ALERT SERVICE BULLETIN No. 37 - Revision 3 -	DOA No. EASA.21J.020
--	--	-------------------------

Subject: MT-Propeller piston O-ring replacement

To: All Owners / Operators of MT-Propeller MTV-5-1-D-C-F-R(A)/()-() which are installed on Allison / Rolls-Royce M250-B17() engine.

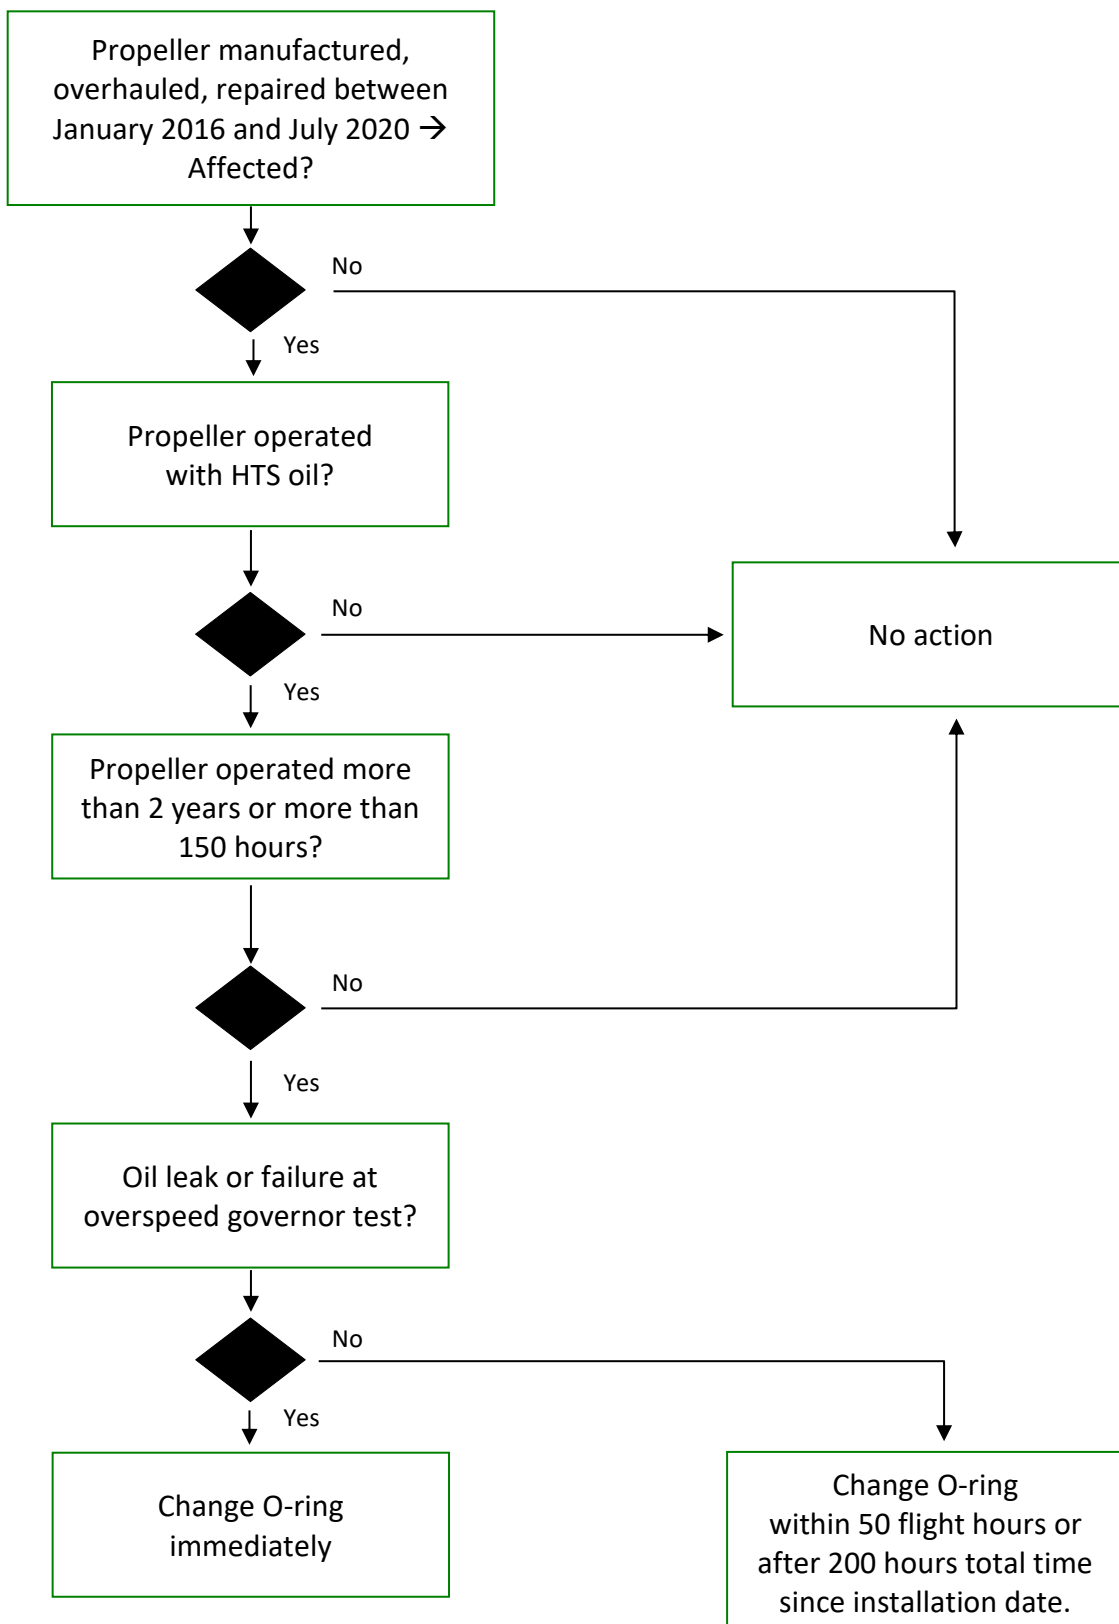
Accomplishment: Replacement of the propeller piston O-ring for propellers installed on the aircraft if it is affected by this Service Bulletin, **as defined on page 2.**
Additionally, but not limited to, if the overspeed governor test according to the applicable AFM fails or any possible signs of oil leak (e.g. signs of oil contamination on the propeller spinner and blades and on the upper and lower engine cowling).
Propellers which are not installed on the engine, should have also replaced the O-Ring before first use **if affected by this Service Bulletin.**

Reason: The above-mentioned engine oils, per standard MIL-PRF-23699-HTS (High Thermal Stability Oil), in example Aero Shell Turbine Oil 560, Mobile Jet Oil 254 or of any other manufacturer, can lead to a swelling of the propeller pitch change piston O-ring. Thus, the friction of the O-ring in the pitch change cylinder area may highly increase, which may lead to a failure of the O-ring and may cause a severe oil leak.

Action: All propeller which are newly manufactured or overhauled or repaired after July 2020 have already the improved piston O-ring **C-047-135-4** installed and if operated with oils approved by MT-Propeller SB-36 (latest revision) do not show any degradation.
All propellers in operation, which are affected, the piston O-ring should be replaced if any possible signs of the overspeed governor test failure or any oil leak is found.
